MALY DENTAL JSP15-81

Consideration at the request of Giffels Webster for approval of the Preliminary Site Plan, Stormwater Management Plan, and Section 9 Façade Waiver. The subject property is located in Section 26, south of Ten Mile Road and east of Novi Road, in OS-1: Office Service District. The site is approximately 1.18 acres and the applicant is proposing to construct a dental office consisting of 4,950 sq. ft. and a parking lot of 40 spaces.

PLANNING REVIEW

Review Date: March 3, 2016
Review Type: Preliminary Site Plan Review
Project Name: Maly Dental
Plan Date: February 4, 2016
Prepared by: Kirsten Mellem, Planner
Email: kmellem@cityofnovi.org **Phone:** (248) 347-0484

Date: 02.04.2016
 Scale: 1"=20'
 Sheet: 06
 Project: 18894.00

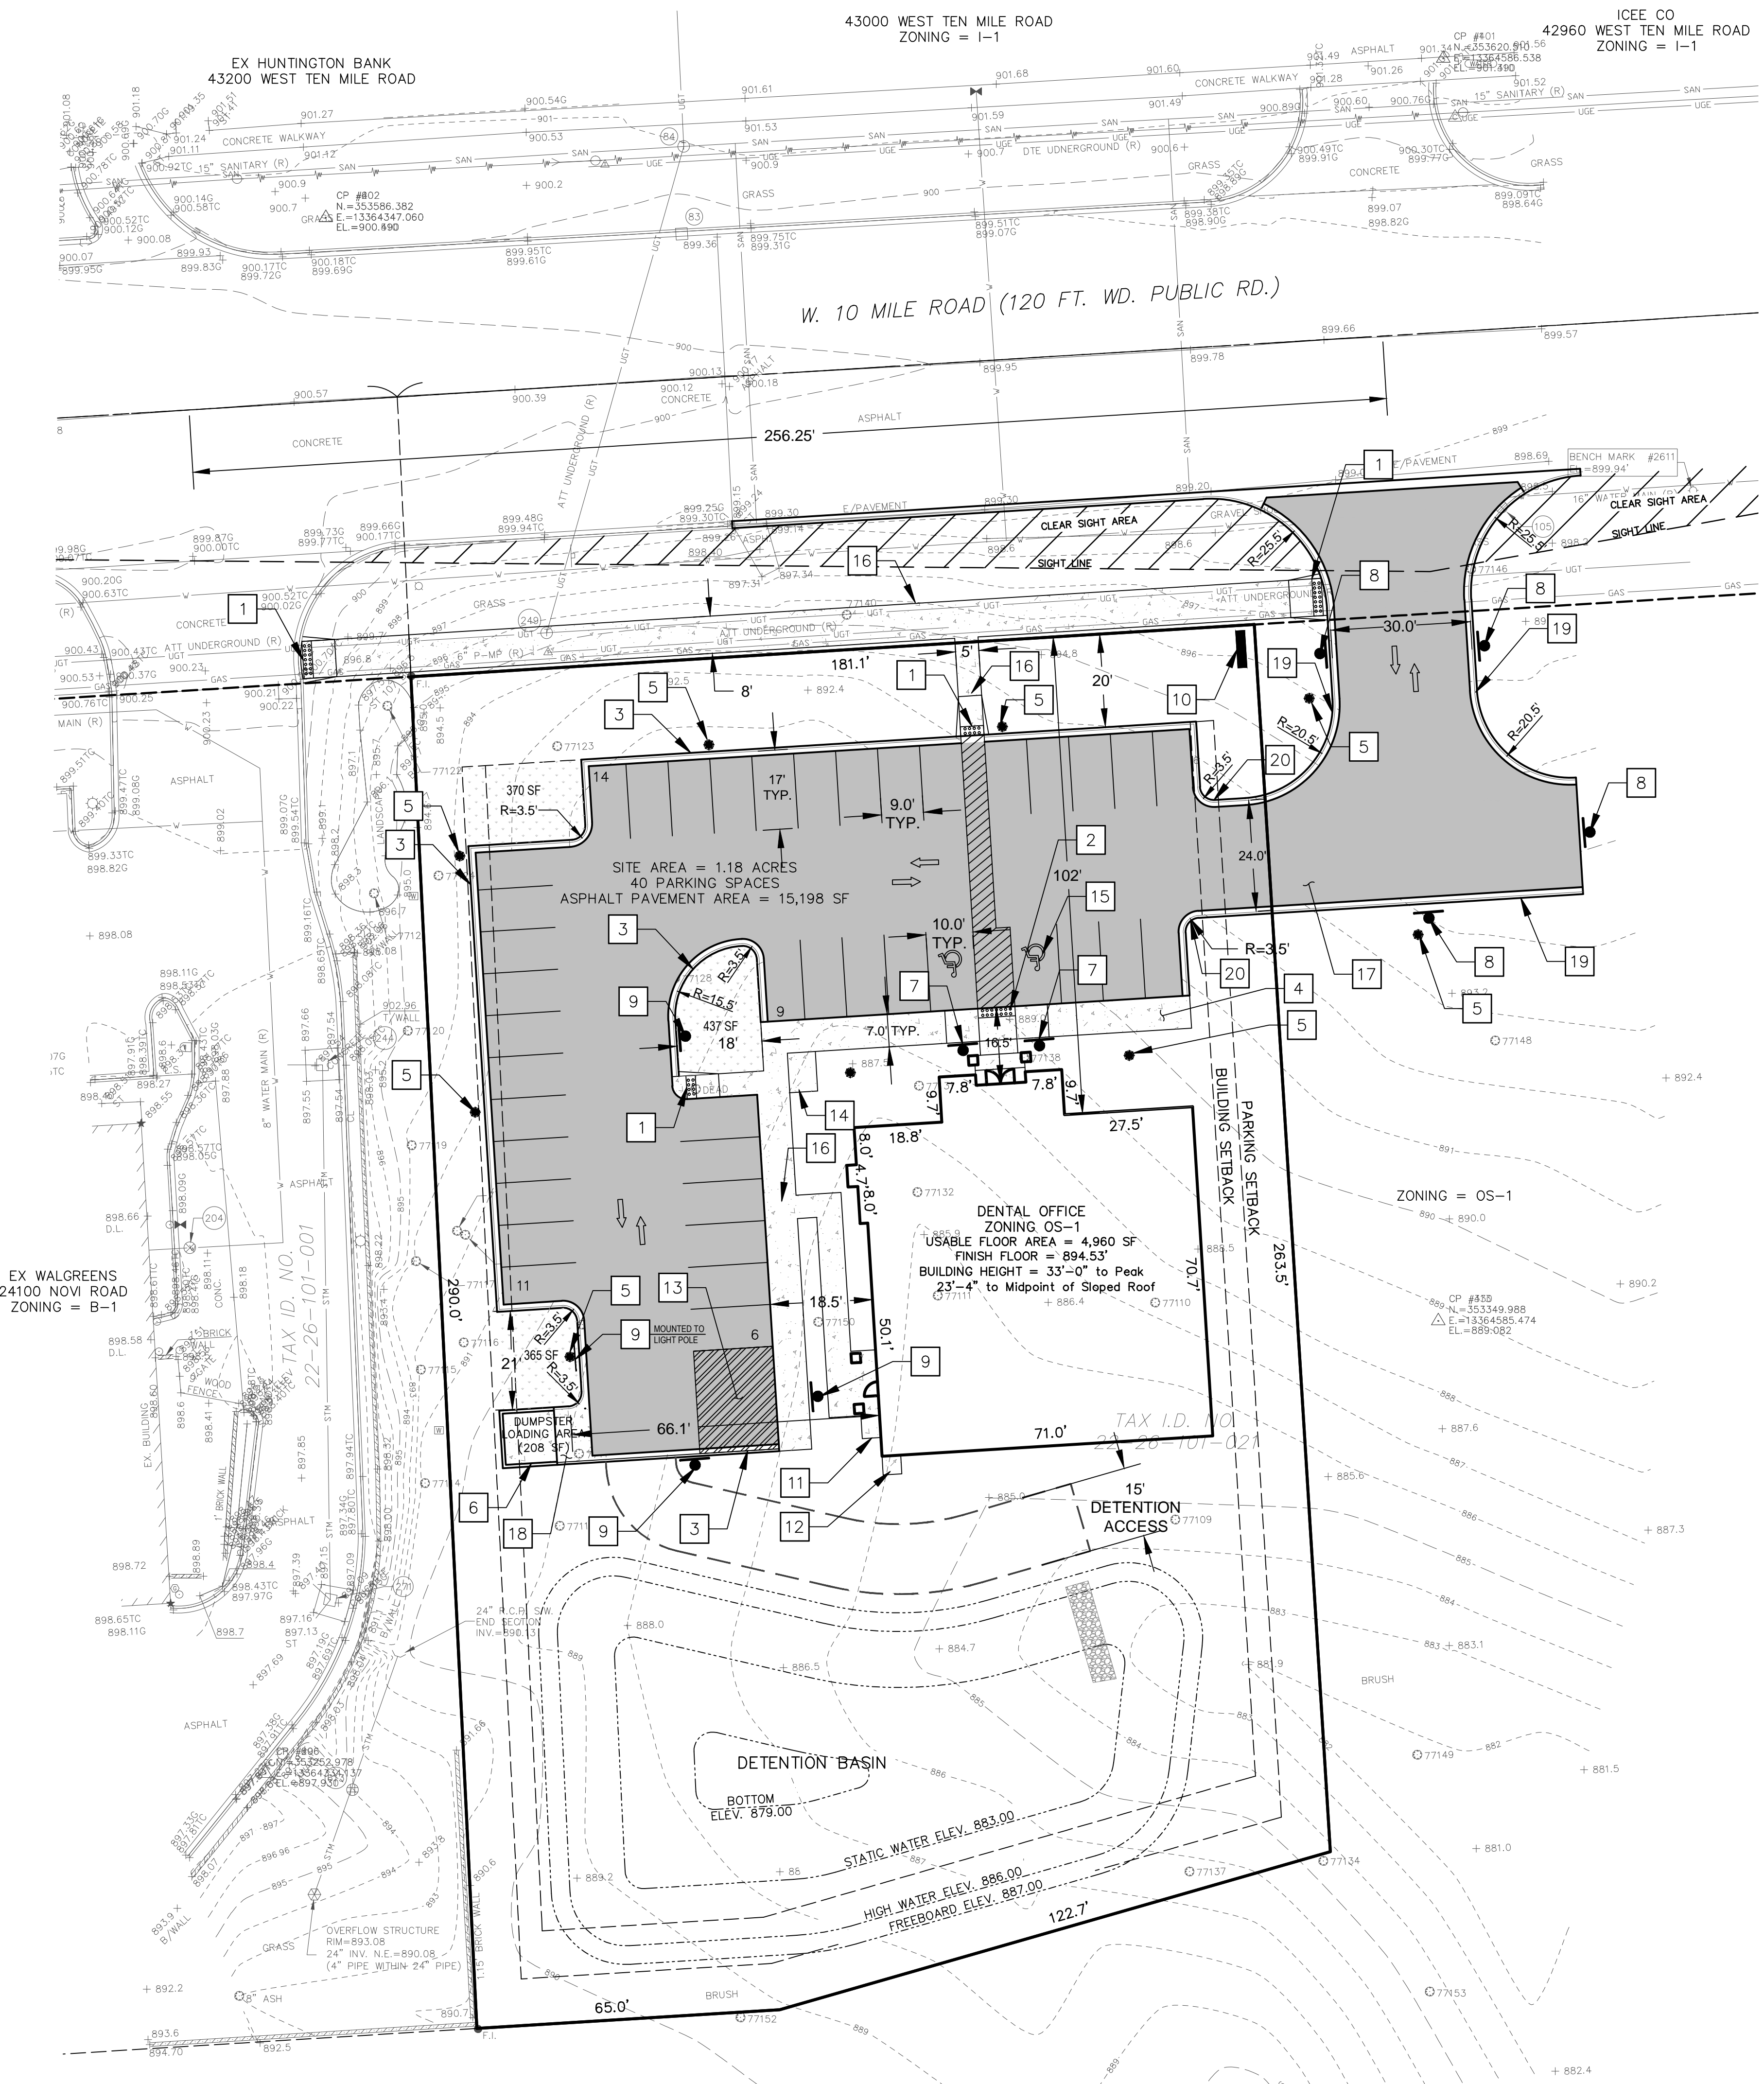
1. Loading Spaces (Sec. 5.4.1): The loading space shall be provided in the rear yard. **The proposed loading area is located in the side yard and will need a ZBA variance to be allowed.**
2. Dumpster (Sec. 4.19.2.F): The dumpster shall be located in the rear yard. **The proposed dumpster is located in the side yard and will need a ZBA variance to be allowed.**
3. Dumpster Enclosure (Sec. 21-145 (c)): The dumpster enclosure shall be screened from public view. **Provide details on the screening materials and dimensions.**

1. We will apply for a ZBA variance for the loading area location. Our application will be submitted on or before March 30, 2016.
2. We will apply for a ZBA variance for the dumpster location. Our application will be submitted on or before March 30, 2016.
3. Details on the screening materials and dimensions of the dumpster enclosure will be included in the Final Site Plan submittal.
4. The driveway to the site is private. An easement from the owner will be recorded as the driveway will not be on Dr. Maly's property.
5. The parcel split documents will be submitted and approved as part of the Final Site Plan review process.

Date: 02.04.2016
Scale: 1"=20'
Sheet: 07
Project: 18894.00

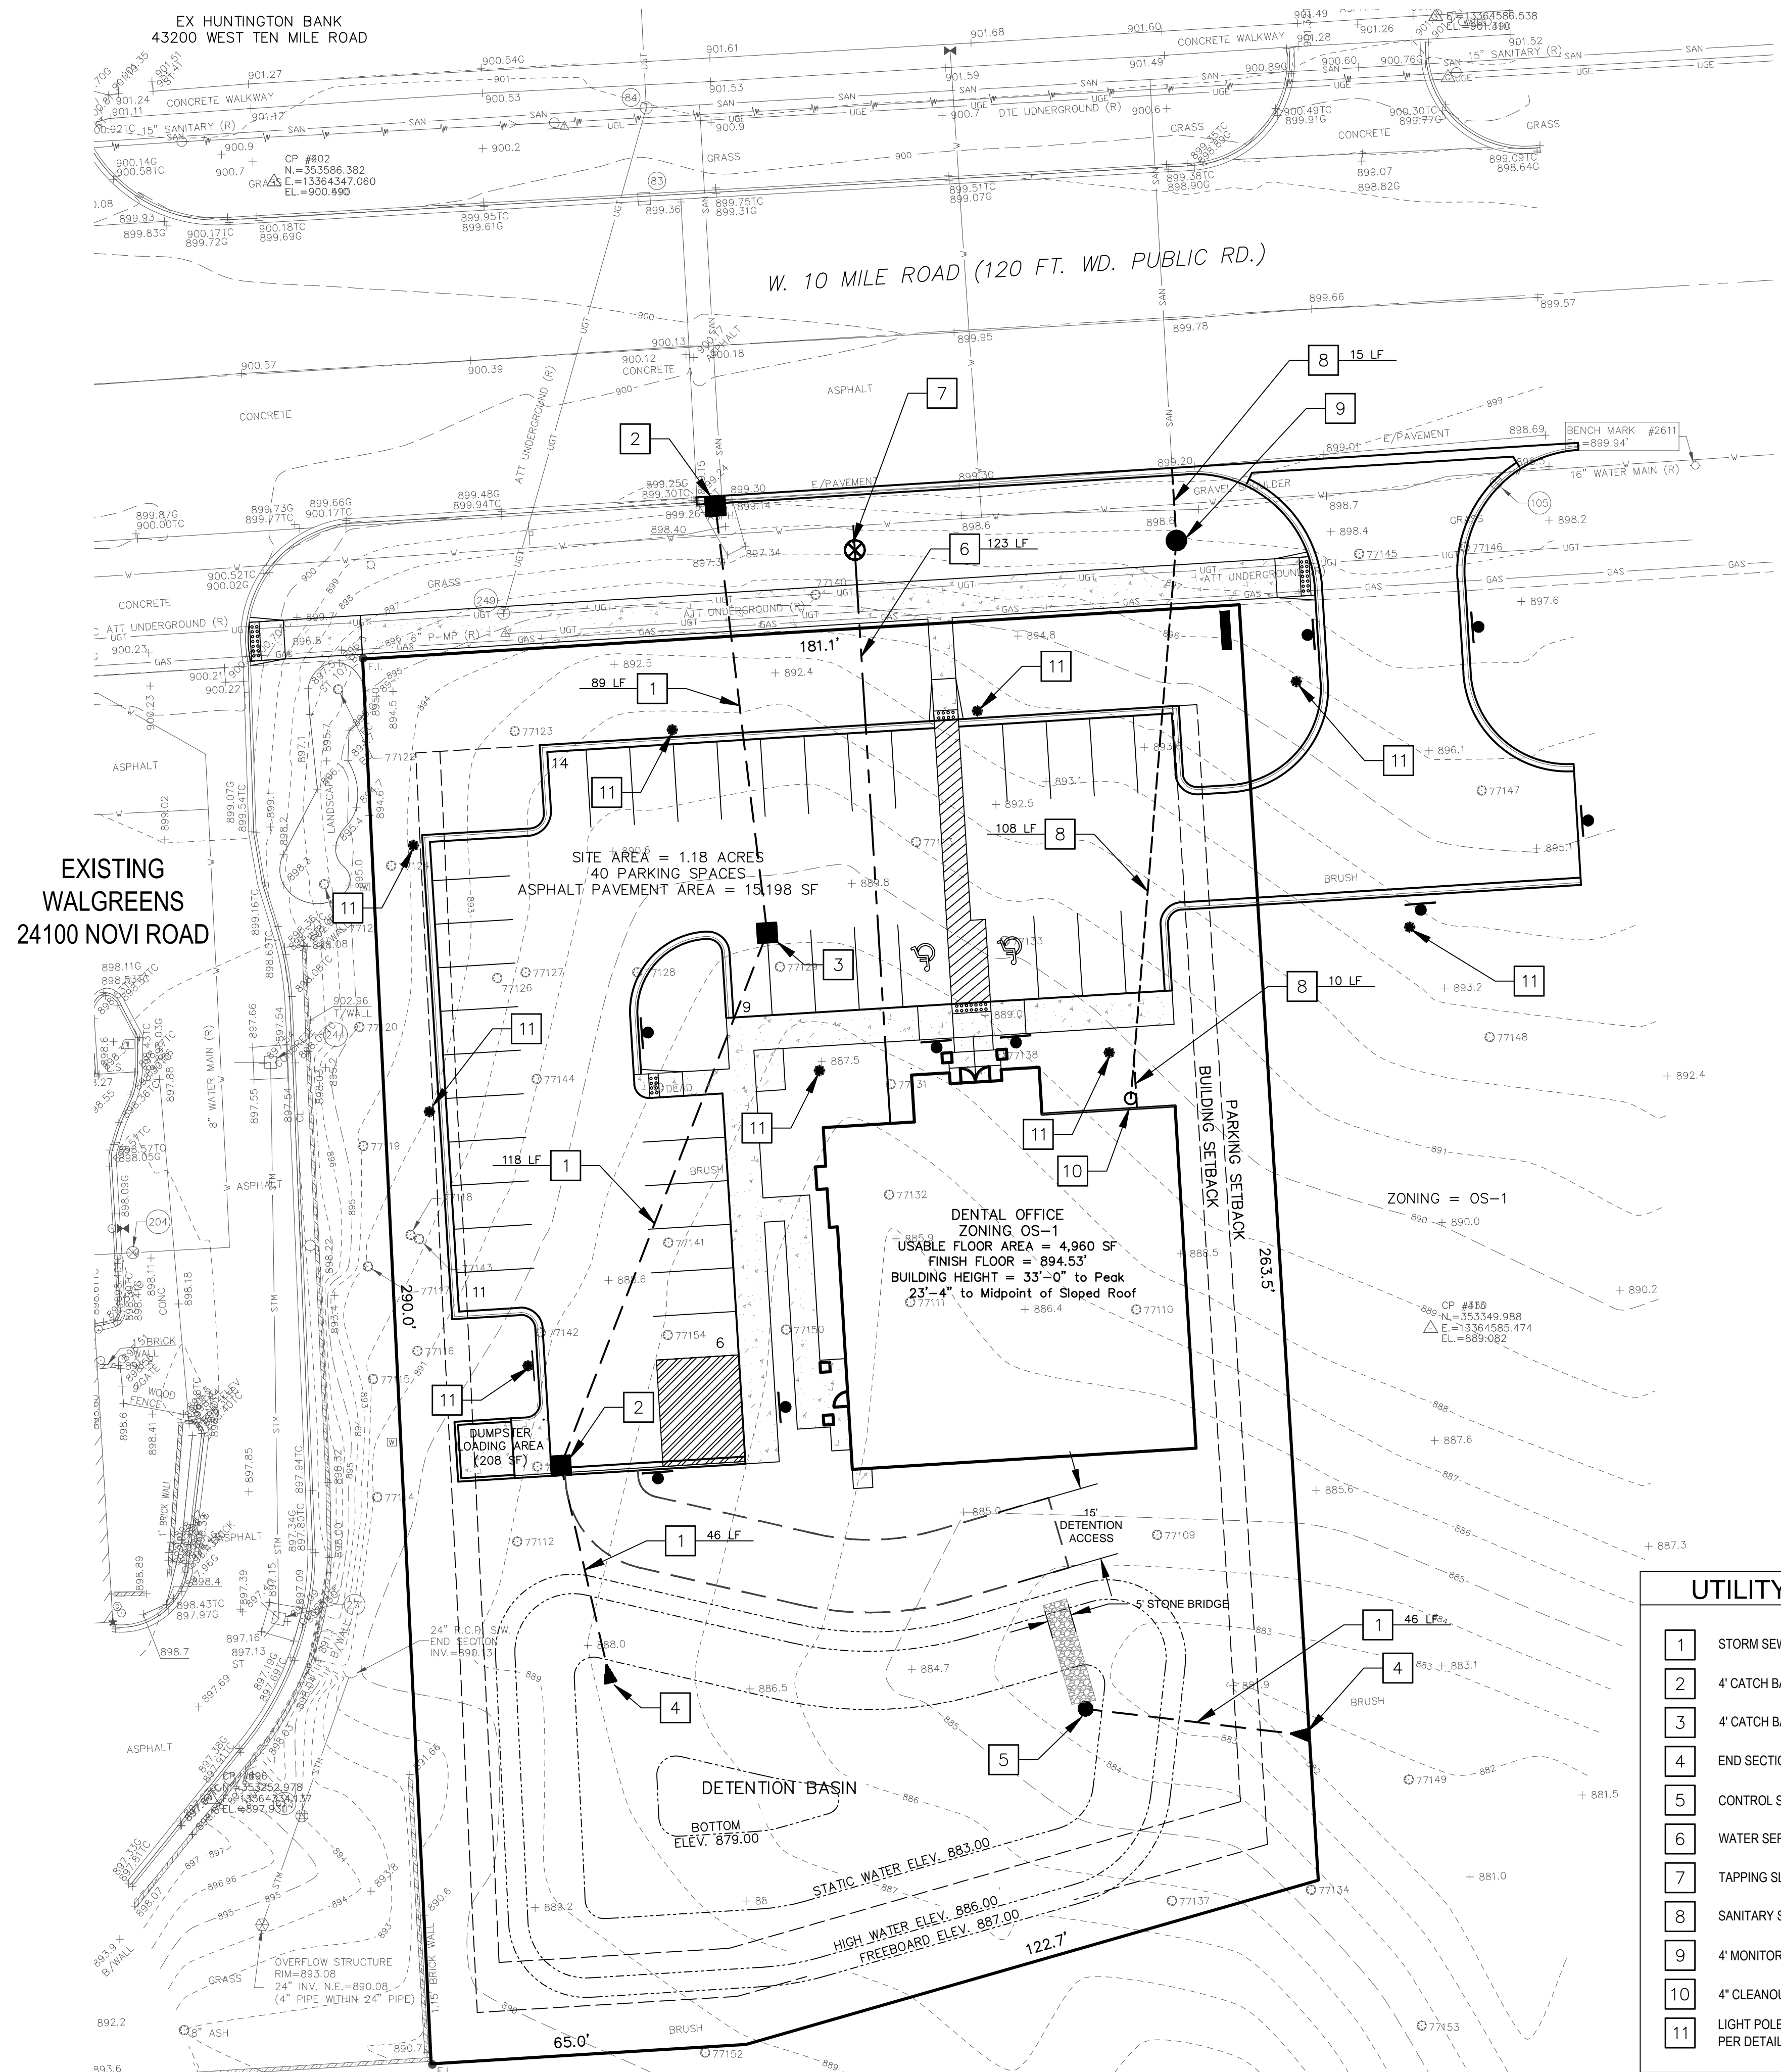
11. A minimum cover depth of 3 feet shall be maintained over all storm sewers. Currently, a few pipe sections do not meet this standard. Grades shall be elevated and minimum pipe slopes shall be used to maximize the cover depth. In situations where the minimum cover cannot be achieved, Class V pipe must be used with an absolute minimum cover depth of 2 feet. An explanation shall be provided where the cover depth cannot be provided.
12. Provide a 0.1-foot drop in the downstream invert of all storm structures where a change in direction of 30 degrees or greater occurs.
13. Match the 0.80 diameter depth above invert for pipe size increases.
14. Storm manholes with differences in invert elevations exceeding two feet shall contain a 2-foot deep plunge pool.

15. Provide a four-foot deep sump and an oil/gas separator in the last storm structure prior to discharge to the storm water basin.
16. Label all inlet storm structures on the profiles. Inlets are only permitted in paved areas and when followed by a catch basin within 50 feet.
17. Label the 10-year HGL on the storm sewer profiles, and ensure the HGL remains at least 1-foot below the rim of each structure.
18. Show and label all roof conductors, and show where they tie into the storm sewer.

NORTH ELEVATION
1/4" = 1'-0"

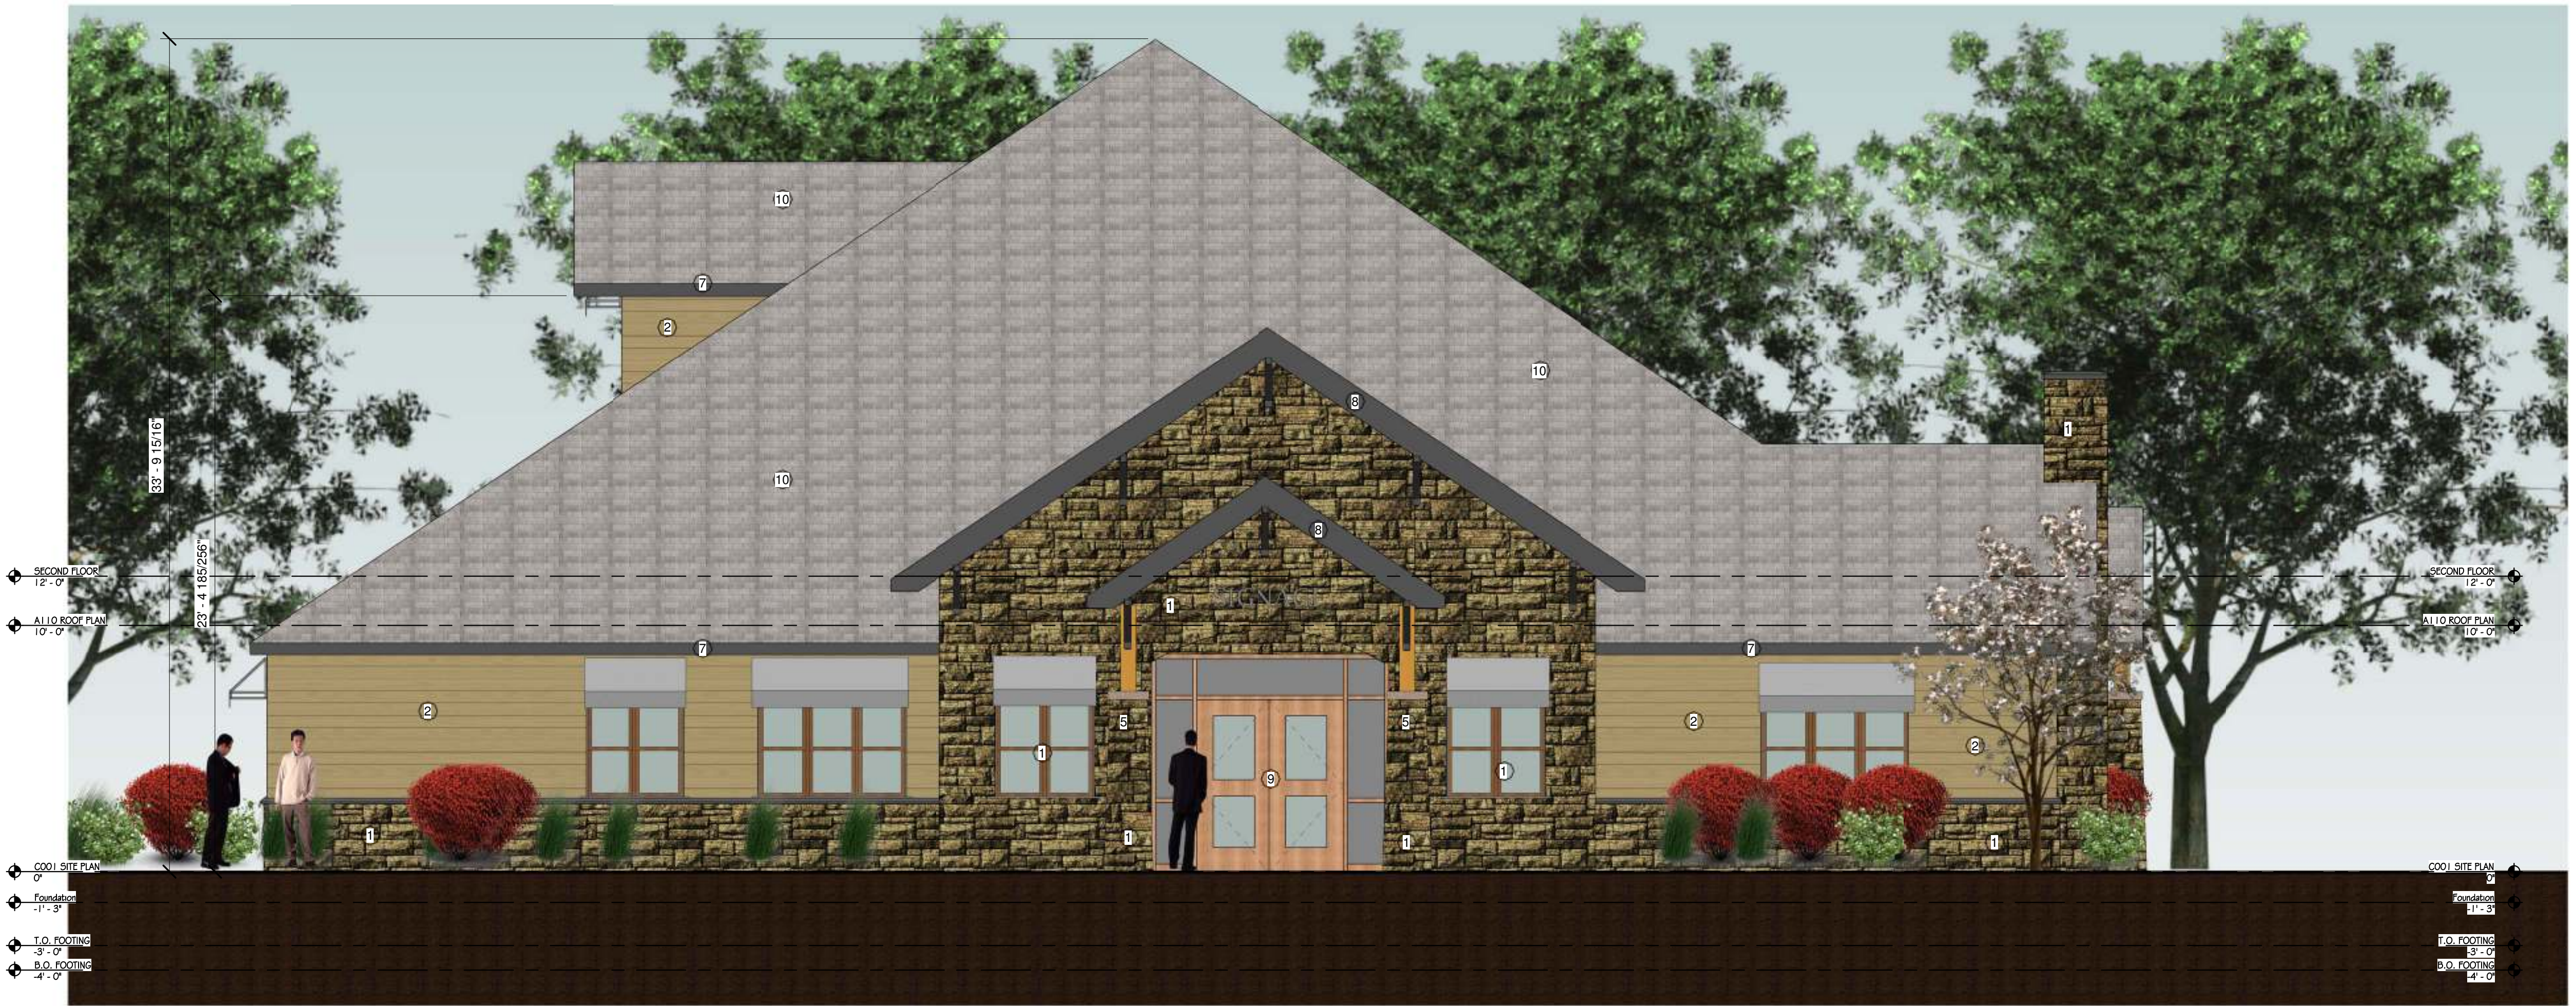
- a. To allow the overage of asphalt shingles (25% allowed; 50%, 59%, 52%, and 58% proposed) because the proposed design will mitigate the expanse of asphalt shingles, which is hereby granted;
- b. To allow the underage of stone or brick (30% minimum allowed; 18%, 25%, and 20% proposed) because the percentage of stone is consistent with the window sill line and increasing the percentage would not add to the aesthetic quality of the design, which is hereby granted;
- c. The findings of compliance with Ordinance standards in the staff review letter and the conditions and the items listed in that letter being addressed.
